REQUEST FOR TECHNICAL REVISION (TR) COVER SHEET

RE: In the Matter of the Box Creek Placer Mine, Permit No. M-2018-053, Technical Revision-03

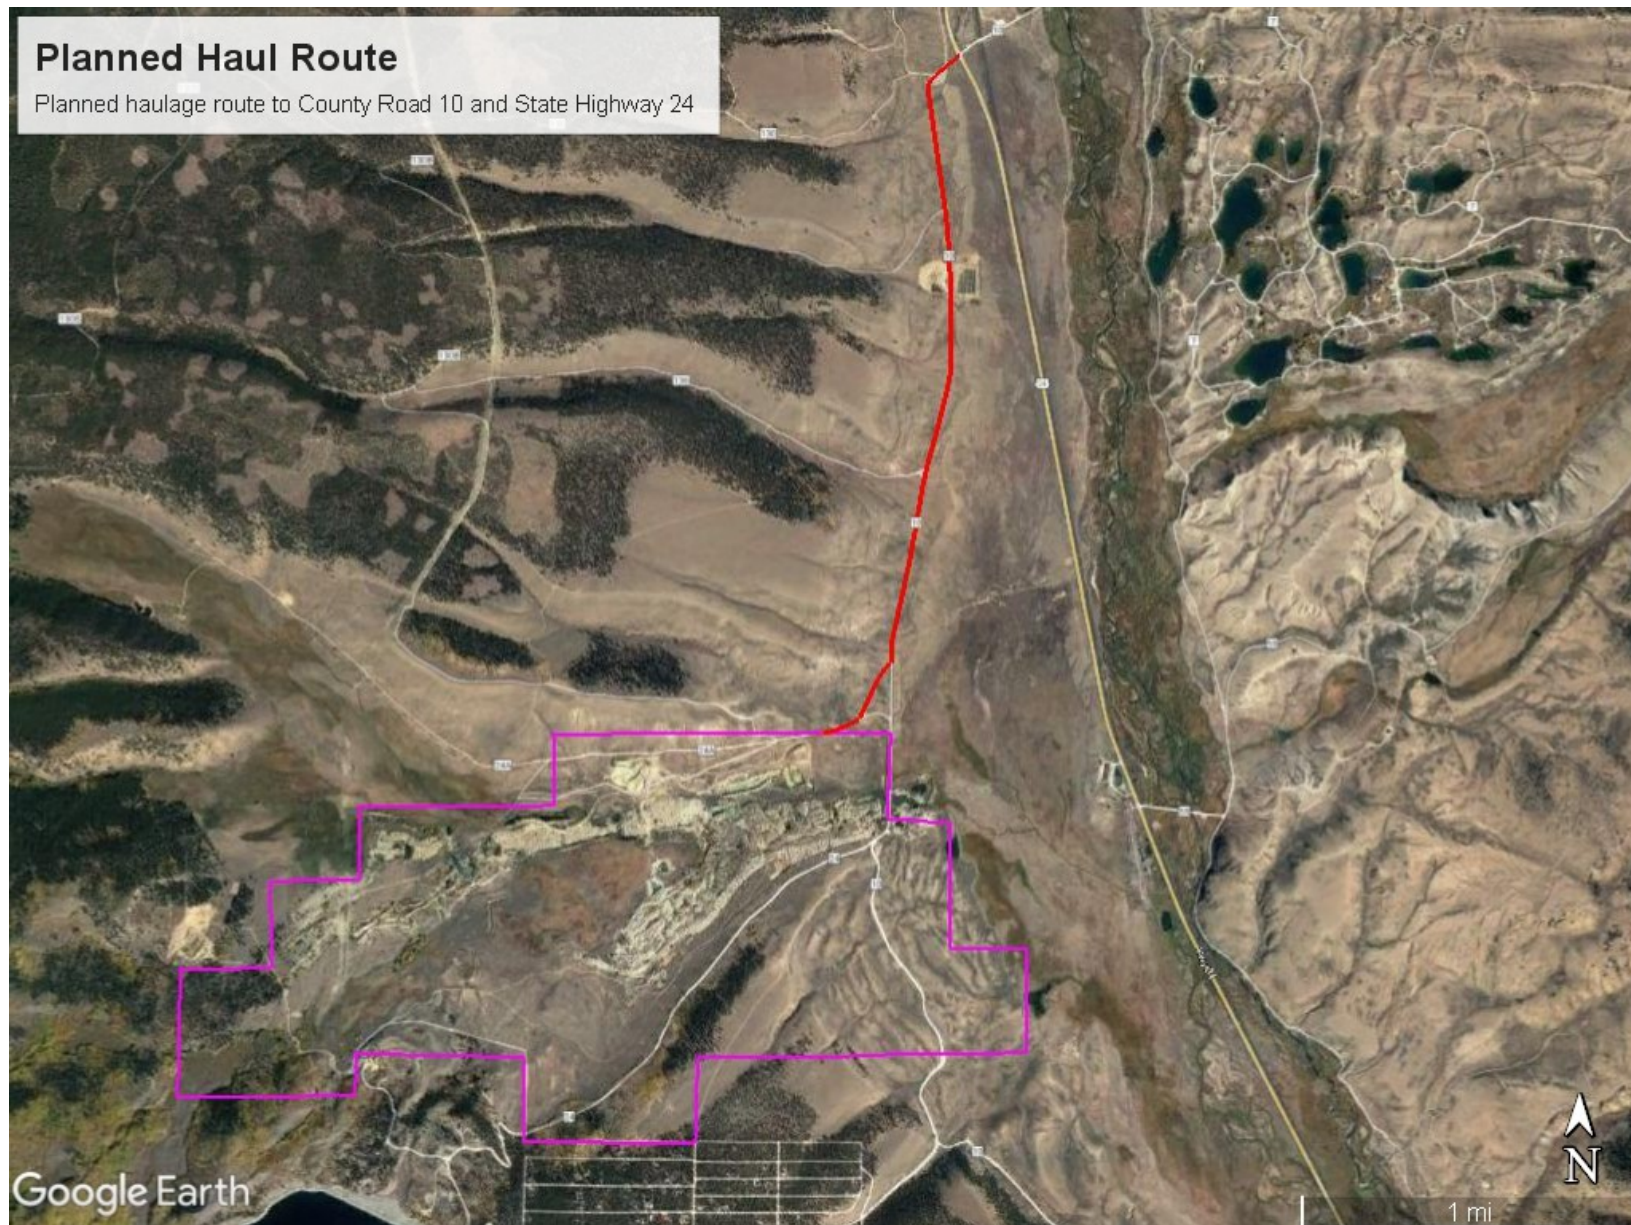
We also plan to submit access permits for gravel hauling along County Road 10 as well as State Highway 24. The planned route is shown in the figure below. Lewicki & Associates has spoken with Lake County's Building and Land Use Department. We believe that the County permit revision is only sensitive to the haulage route. We anticipate that our access permits may include a dedicated haulage route to avoid adversely impacting the city of Leadville.
